## Detailed Site Plan Departure from Design Standards

**DSP-18039**  
**DDS-651**

Application	General Data	
<p><b>Project Name:</b> Townes at Peerless</p> <p><b>Location:</b> On the west side of US 301 (Robert Crain Highway), approximately 0.15 mile north of its intersection with MD 725 (Marlboro Pike).</p> <p><b>Applicant/Address:</b> Peerless Avenue Associates, LLC 1000 University Avenue, Suite 500 Rochester, NY 14607</p>	Planning Board Hearing Date:	03/21/19
	Staff Report Date:	03/07/19
	Date Accepted:	01/16/19
	Planning Board Action Limit:	03/27/19
	Plan Acreage:	7.64
	Zone:	M-X-T
	Dwelling Units:	62
	Gross Floor Area:	3,000 sq.ft.
	Planning Area:	79
	Council District:	06
	Election District:	03
	Municipality:	N/A
	200-Scale Base Map:	206SE13

SUBJECT: Detailed Site Plan DSP-18039  
Departure from Design Standards DDS-651  
Type 2 Tree Conservation Plan TCP2-003-2019  
Townes at Peerless

# SIGNAGE

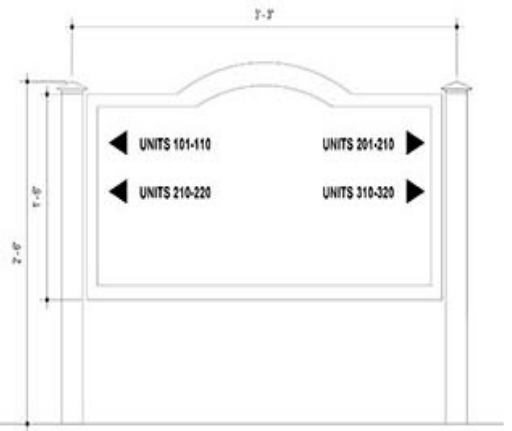
- a. Revise the primary identification sign to include a brick base to match that of the building and move it out of the public utility easement.
- b. Provide physical elements, such as fencing or landscaping, to more clearly define a separation between the residential and commercial portions of the development, and incorporate the wayfinding sign into this design, where appropriate, to be reviewed and approved by the Urban Design Section as designee of the Prince George's County Planning Board.
